| Title: Susitna-Watana Hydroelectric Project, FERC Project No. 14241-000 ; Review of Initial Study Reports | | SuWa 292 |

Subject: Susitna-Watana Hydropower Project, FERC Project No. 14241-000; Review of Initial Study Reports

Enclosure 3: Individual study requests for modification and new study

Figure 1. Cross section and distribution of bedload discharge, Susitna River at Susitna Station, August 15, 1984 (Knott et al. 1986).

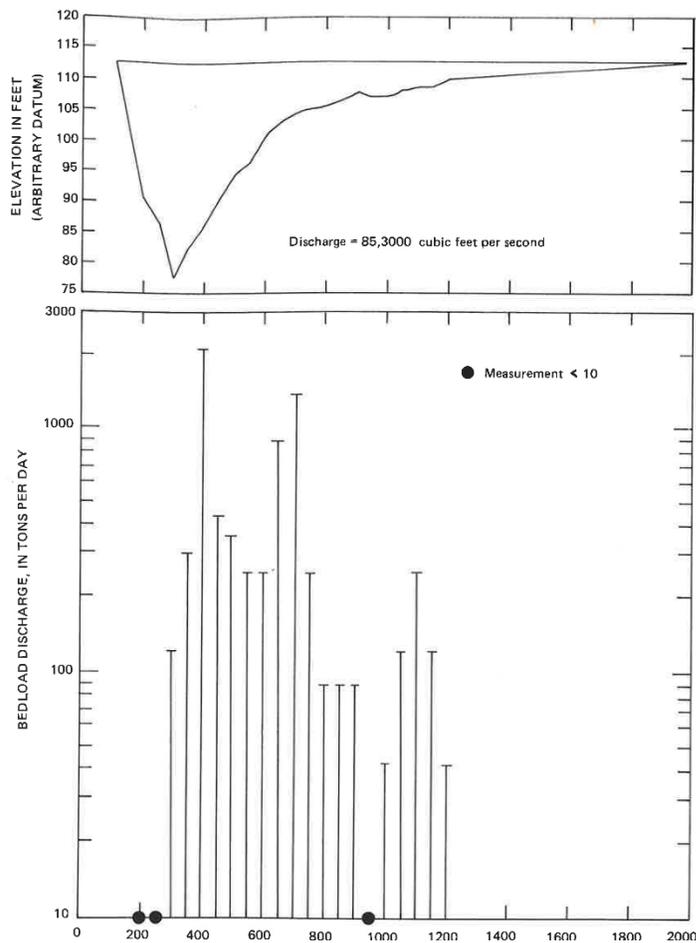
Given that Ferguson (2003) demonstrated that 1-D models tend to severely underestimate bedload transport in gravel-bed rivers, the entire Susitna River study reach from PRM 29.9 to PRM 187.1 should be modeled using a 2-D Bed Evolution Model (BEM) for the 50 years of FERC licensing period. However, performing 2-D fluvial geomorphology simulations in such a large modeling domain combined with multi-year modeling periods is not practical at the moment due to current limitations in computer power and a lack of sufficiently detailed channel morphology data. Therefore, AEA's proposed use of a 1-D reach-scale (from PRM 29.9 to PRM 187.1) BEM for assessing the long-term and cumulative effects over the 50 years of FERC licensing period combined with the use of a 2-D local-scale BEM for more detail short-term (~6 months) analyses in 10 selected Focus Areas is a non-ideal, but necessary compromise for modeling the geomorphic effects of the Project. The limitations of the 1-D reach-scale and the 2-D local-scale BEM should be clearly identified and stated such that the usefulness of the modeling results is transparent. The selected Focus Areas for the 2-D local-scale BEM are supposed to be representative of each of the geomorphic reaches where they are located. The main issue with 1-D model is that there is a single width-averaged value of a hydraulic parameter (e.g. depth, velocity, shear stress) as representative of the entire cross section, neglecting the variability across the channel width. This is a good approximation only when the channel section is rectangular in shape. Because bedload transport laws are nonlinear, a disproportionate amount of the total bedload in a cross section is transported along the deepest part of the river channel where velocity and shear stress are normally highest. Figure 1 illustrates how bedload transport in a section of the Susitna River varies by orders of magnitude across the channel width.

According to Ferguson (2003) “simple width averaging leads to severe underestimation of bedload transport in most conditions”. Ferguson proposes “averaging only in the areas of the channel with above-average depth or shear stress”; but this may be difficult to implement as it will require changing the programming code of the 1-D model. One possibility could be to restrict the ‘effective’ or ‘active’ width for sediment transport to only the deepest part of the channel if the 1-D software has that capability; but even in that case the active width will not be constant but vary with discharge. Another suggestion could be to reduce the critical shear stress (or sediment size) to artificially increase bedload transport.

Figure 2. Morphological changes following flow regulation in Peace River: (a) Cross section. (b) Tributary mouth (Church, 1995).

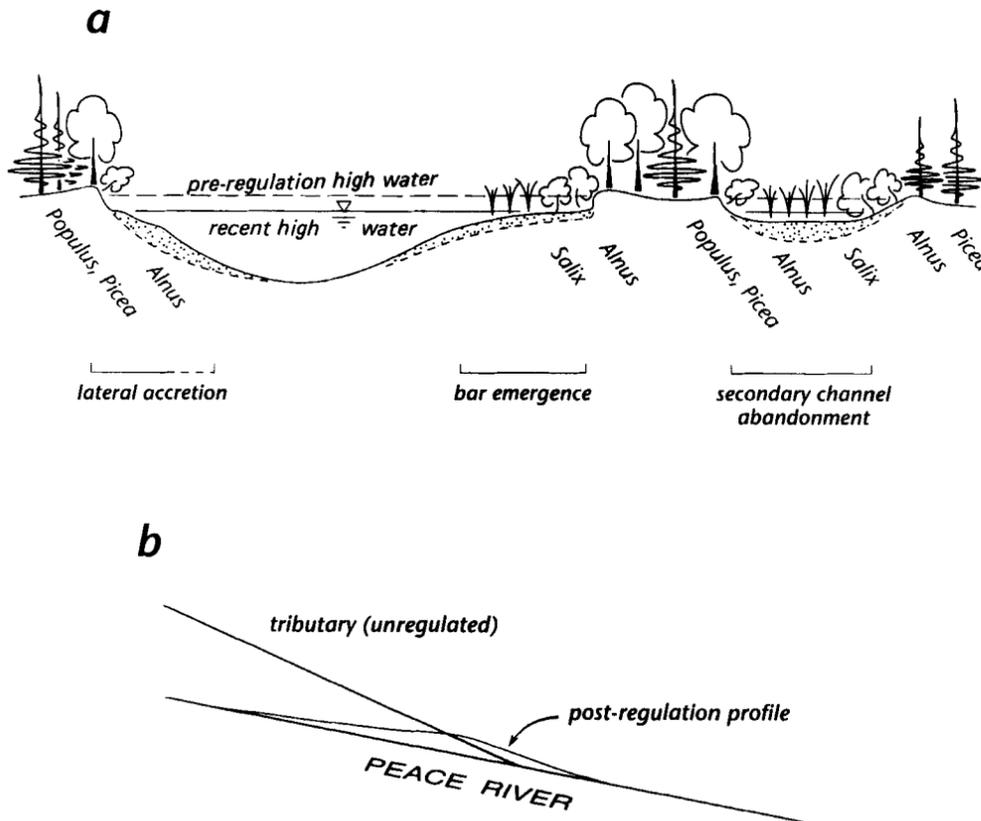
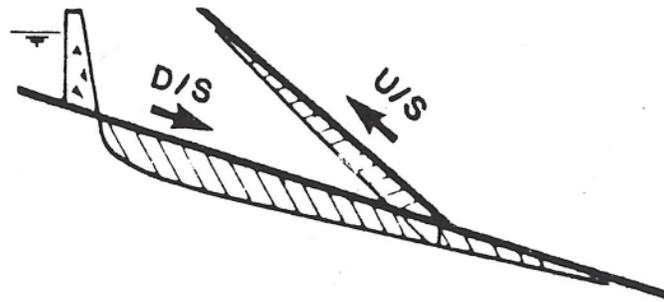
In the ISR statement above, it is not clear if the proposed tributary modeling approach will reproduce the effects documented above because it does not demonstrate that there is a dynamic feedback between the main stem and the tributaries. It almost appears as if the tributaries will be modeled simply as point sources of sediment into the main stem, which may not be correct as pre-Project tributary supply and distribution will be different from post-Project supply.

Because post-Project water levels along the main stem of the Susitna River will be typically lower during the summer season when tributary flows are peaking and their sediment supply is highest, the water surface slope along the tributaries discharging into the Susitna Middle Reach will be locally steeper near their mouths, meaning that flow velocity and sediment transport along the tributary near the mouth will locally increase (until a new equilibrium condition is re-established). This potential post-Project increase in sediment loads from Middle Reach tributaries will be neglected if tributary loads are estimated using existing pre-Project conditions and then imposed as static fixed point sources in the 1-D main stem model. Also, if the main stem suffers from bed degradation, the bed level along the tributaries will also degrade following a process of upstream progressing degradation

Especially below a dam, tributary contributions of sediment are very important to channel morphology. If tributaries are viewed as static point sources of sediment then the study is not being conducted as provided for in the approved study plan because it fails to incorporate a known crucial element.

Figure 4. Bed changes along Middle Susitna River over a period of 50 years reported in Figure 5.1-9 of Fluvial Geomorphology Model Development - Technical Memorandum (Nov. 2015).

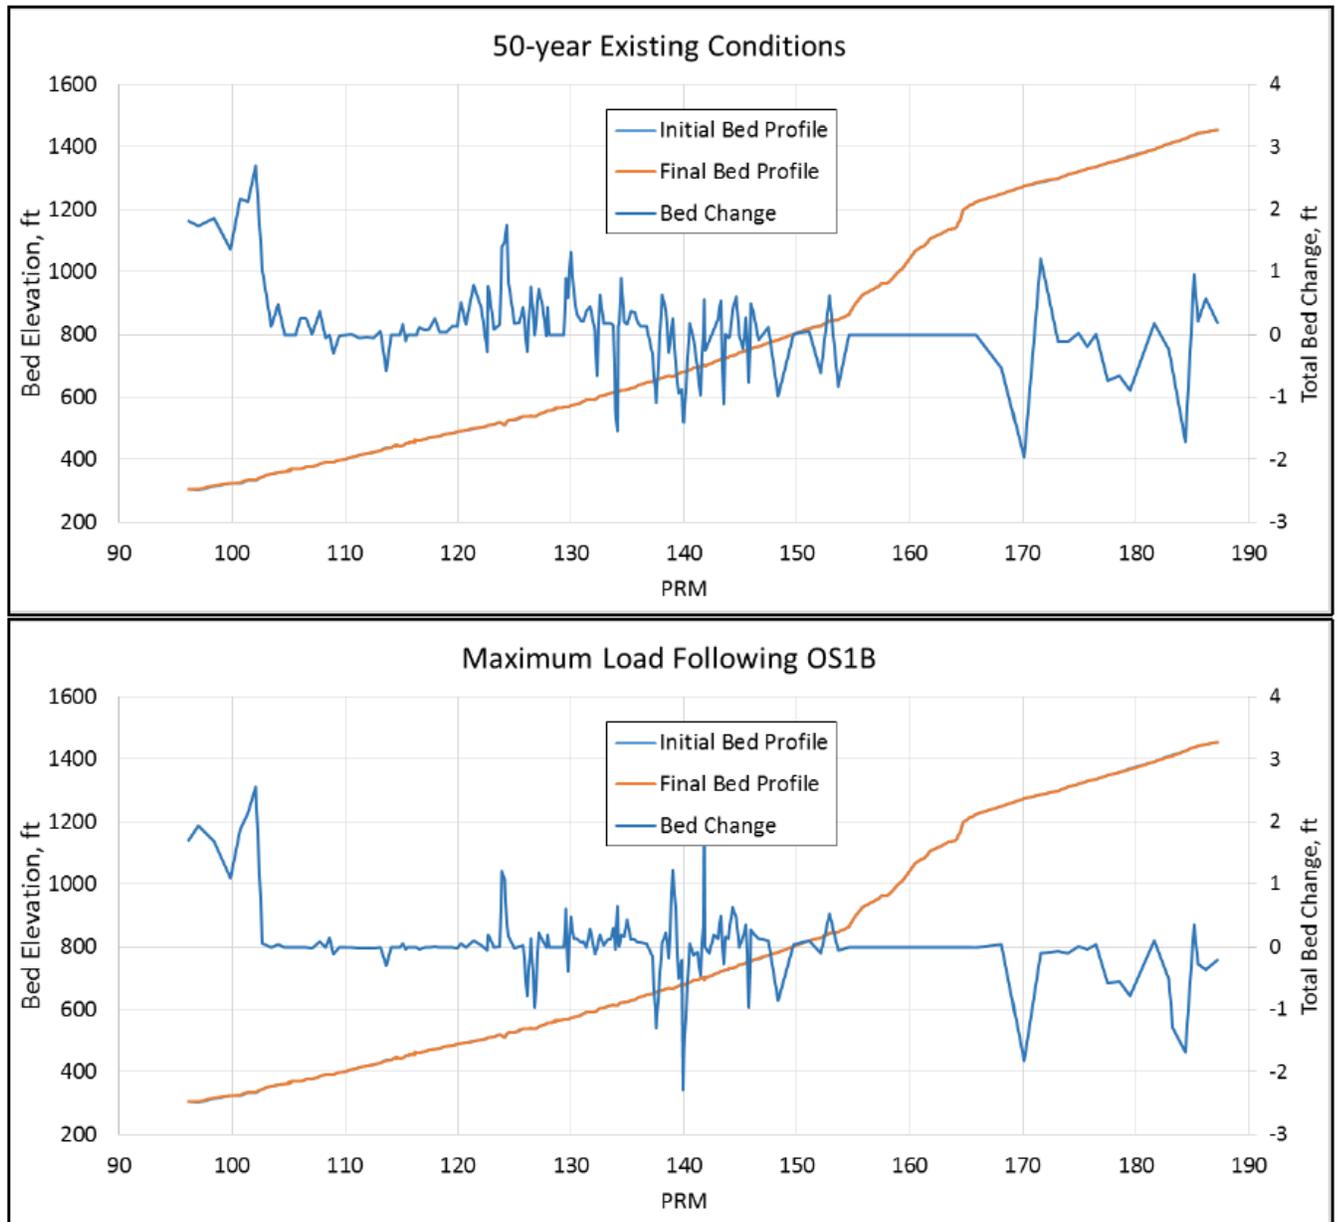
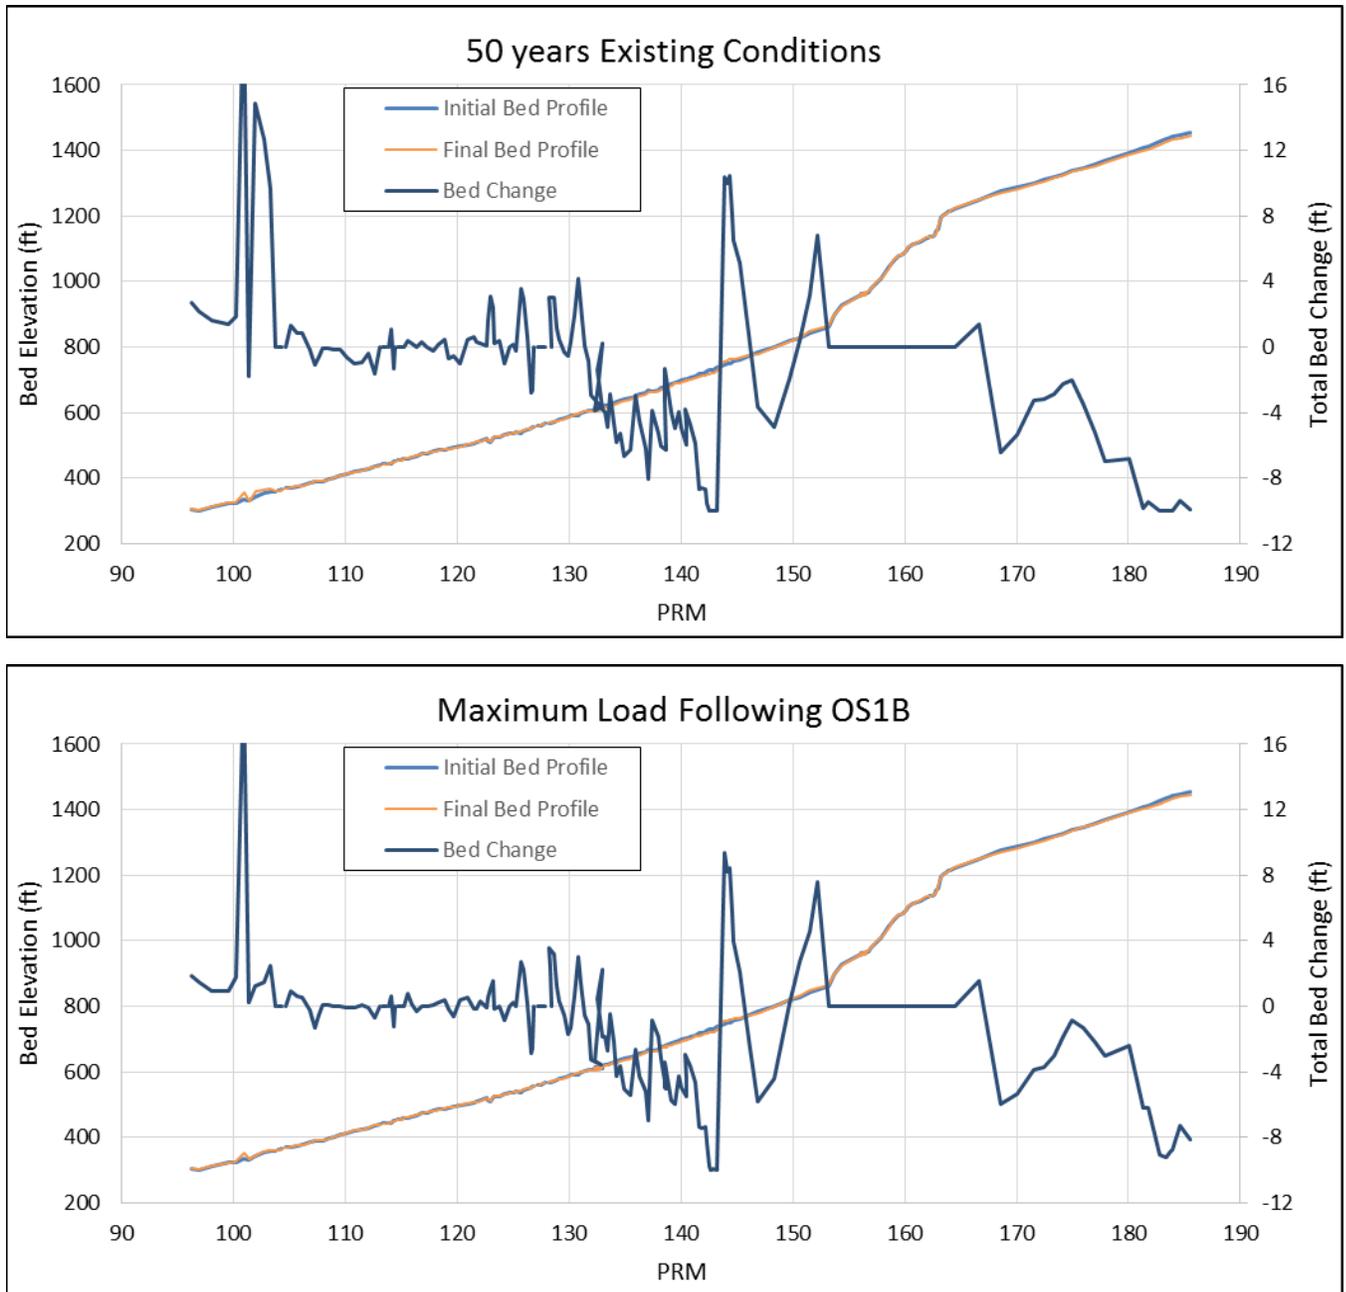
Figure 5.1-9 [Figure 4] shows Middle River bed elevation change at each cross section over the 50-year simulation period with the channel profile for reference. Throughout the Middle River bed elevation changes are predominantly between +/- 1 foot and rarely exceed 2 feet of change in 50 years. (pg. 30).

Figure 4 below shows the original Figure 5.1-9 mentioned in the report. The scale on the right vertical axis shows the magnitude of bed elevation change in the range of +4 feet (deposition) to -3 feet (erosion). In agreement with the statements made in the report, largest bed degradation reaches down to -2 feet, but in general it remains small.

Figure 5 shows the bed elevation changes computed by running the HEC-RAS model downloaded from the Susitna-Watana web server (approximately 3/1/2016), plotted in a similar format as but with the scale of the right vertical axis expanded 4 times between +16 feet and -12 feet. Notice that degradation is much stronger, reaching values of -10 feet, which is the maximum scour depth allowed in the model (i.e. the model assumes non-erodible bedrock 10 feet below initial bed level).

In order to further verify that the large degradation shown in Figure 5 was not a consequence of erroneous post-processing of the model results on our part, the transverse profiles of the most upstream cross section (Project River Mile – PRM 187.2), immediately below the proposed Watana dam site, were extracted as shown in Figure 6. The two cross section plots are direct outputs from HEC-RAS without any post-processing. They show degradation of 10 feet for the Existing condition and 8 feet for the Max LF OS-1b, which is counterintuitive as more degradation will be expected when the dam is included in the model.

These large discrepancies between the reported values (Figure 4) and the values obtained by running the posted 1-D BEM model (Figure 5) should be explained before the 1-D and 2-D BEM results can be considered valid (the 2-D model uses input from the 1-D model).

Figure 7. Bed changes in the Middle Susitna River predicted by 1-D open water model for existing conditions (without dam) over a period of 50 years, showing location of pass through nodes.

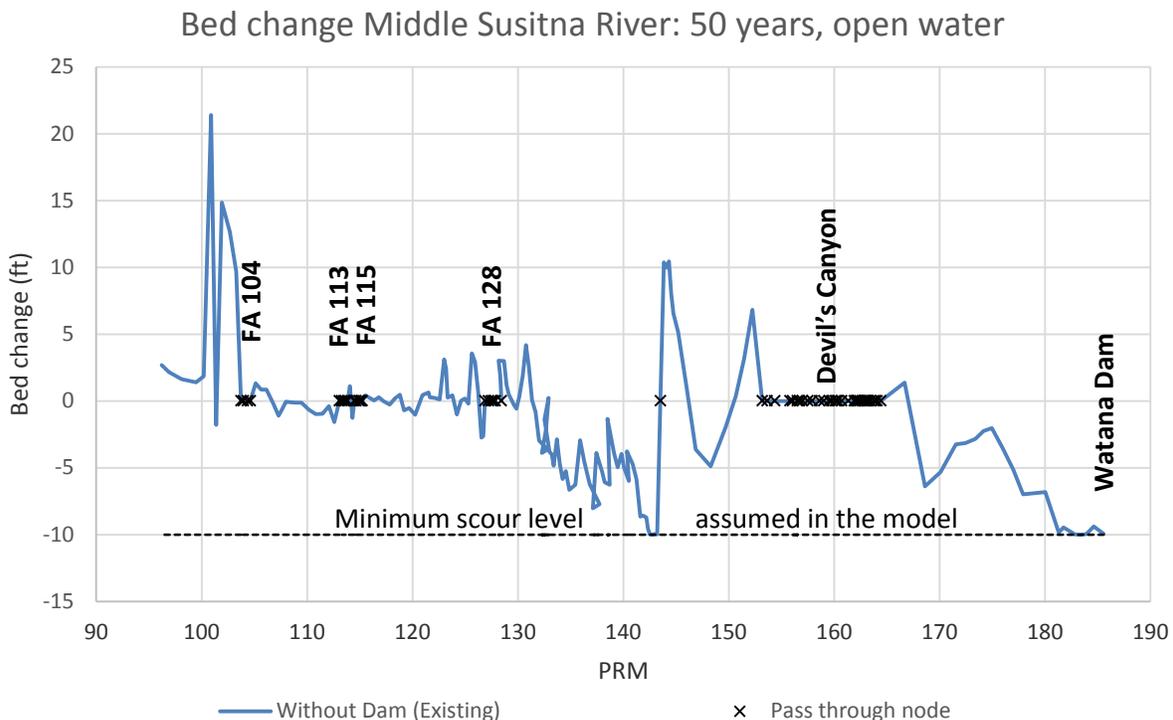
Pass-through nodes are cross sections in the HEC-RAS model where incoming sediment from upstream simply passes through without causing erosion or deposition (i.e. bed change is forced to zero at a pass-through node). The use of pass-through nodes is justified in steep bedrock reaches such as Devil's Canyon, but never in alluvial reaches (the Susitna River is an alluvial system) where the bed is free to change due to erosion or deposition. In the HEC-RAS model downloaded, there are 70 pass-through nodes out of 166 cross sections, including Focus Areas FA 104, FA 113, FA 115 and FA 128. The location of pass-through nodes in the Middle River HEC-RAS model is shown in Figure 7, plotted against the bed changes computed for the Existing conditions.

Figure 7 shows clearly how the presence of pass-through nodes forces bed changes to be zero, which outside Devil's Canyon is unwarranted and defeats the main purpose of the 1-D BEM, which is precisely to predict bed changes. The reason for using pass-through nodes in the alluvial flow split areas is due to present limitations in the HEC-RAS 5.0 beta version model, as mentioned in AEA's *Attachment 1: Appendix A. 1-D Bed Evolution Model of the Middle and Lower Susitna River*:

Figure 8. 50 year mean annual bed change predicted by 1-D model for both existing conditions and Maximum LF-OS1b.

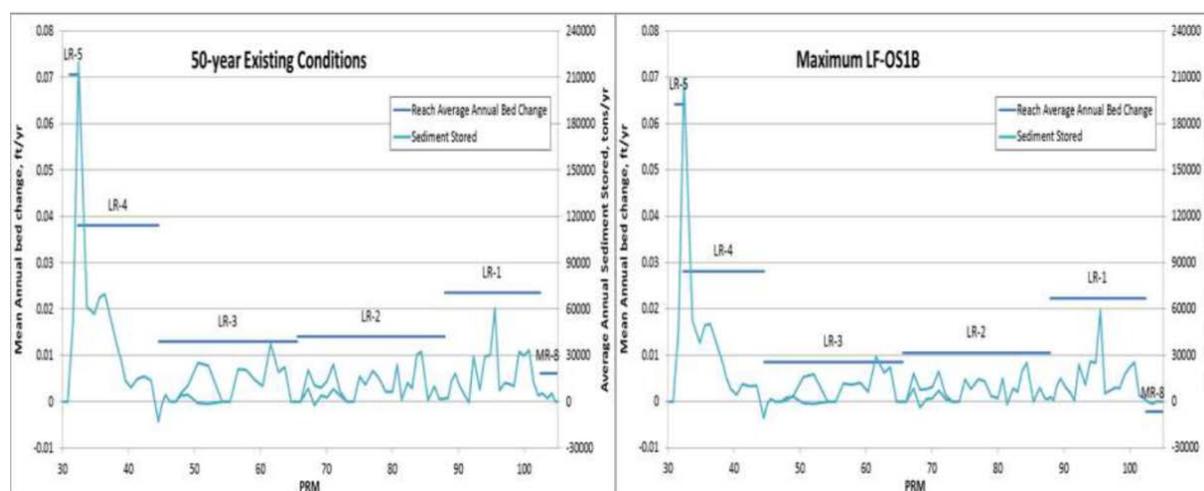
Predicted Bed Changes - The results of the 1-D sediment transport model along the Lower Susitna River are shown in Figure 9 (below). Due to its lower slope and proximity to the sea, the river tends to deposit sediment in this reach making it aggradational (i.e. annual bed changes are positive). This figure also shows that the dam operation following LF OS-1b decreases the degree of aggradation in the Lower Susitna River as expected, since sediment trapped from the dam will no longer be delivered to this reach. However, the geomorphic effect of dams on downstream river reaches tends to dissipate away from the dam (i.e., degradation is most intense near the dam and decreases along the river in the downstream direction). Then, AEA's model is rather surprising that the reach LR-1 exhibits much smaller bed change that reaches LR-2 through LR-5, which are located farther downstream.

Based on the modeling results presented above (Figure 8) the channel will aggrade at 9 inches a decade or 4 feet over the first 50-years of the project. 4 feet of bed change in a river that is at least ½ mile wide seems to be outside the range of natural variability. If the model predicts effects that are significant 150 miles below the dam, it is reasonable to expect them to effect the last 30 miles to Cook Inlet also. This rate of aggradation will shorten the length of channel that is intertidal, thereby potentially decreasing eulachon habitat.

Figure 9. Bed elevation change between existing conditions and LF-OS1b as predicted by 1-D model (i.e. the impact of the Watana Dam on bed levels).

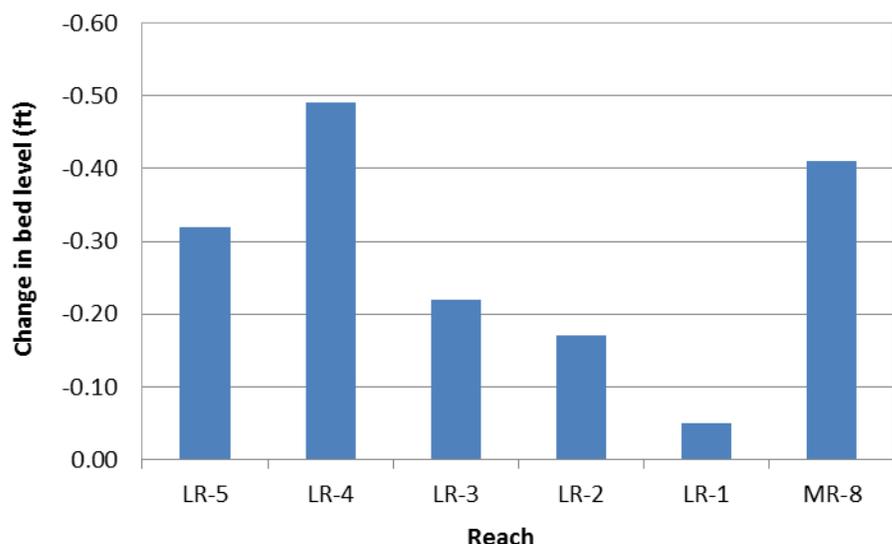
Also, 9 shows the difference in bed changes predicted by the 1-D at the end of the 50-year period, computed by subtracting the bed changes with-Project (Table 5.3-2) minus the existing conditions (Table 5.3-1). These values represent the net effect of the Project. Again, bed changes increase downstream of LR-1. Surprisingly, the model predicts that Watana Dam will generate larger bed changes in reach LR-4 farther downstream than those in MR-8. These results are counterintuitive, needing clear explanation.

The overall decision of not extending the bed evolution model downstream of PRM 29.9 due to predicted small changes caused by the Project is not currently supported by their modeling. By AEA's own account during the March 2016 ISR meeting, this decision is also not supported by the scientific literature reporting on empirical evidence from other dammed systems. Although AEA anticipates that the influence of the large tributaries discharging into the Lower Susitna River will dissipate the effects of the dam on hydraulics and sediment transport, the predictions made by the 1-D bed evolution that bed changes increase downstream, or even are larger in reach LR-4 than MR-8, raise some doubts about AEA's 1-D model capabilities.
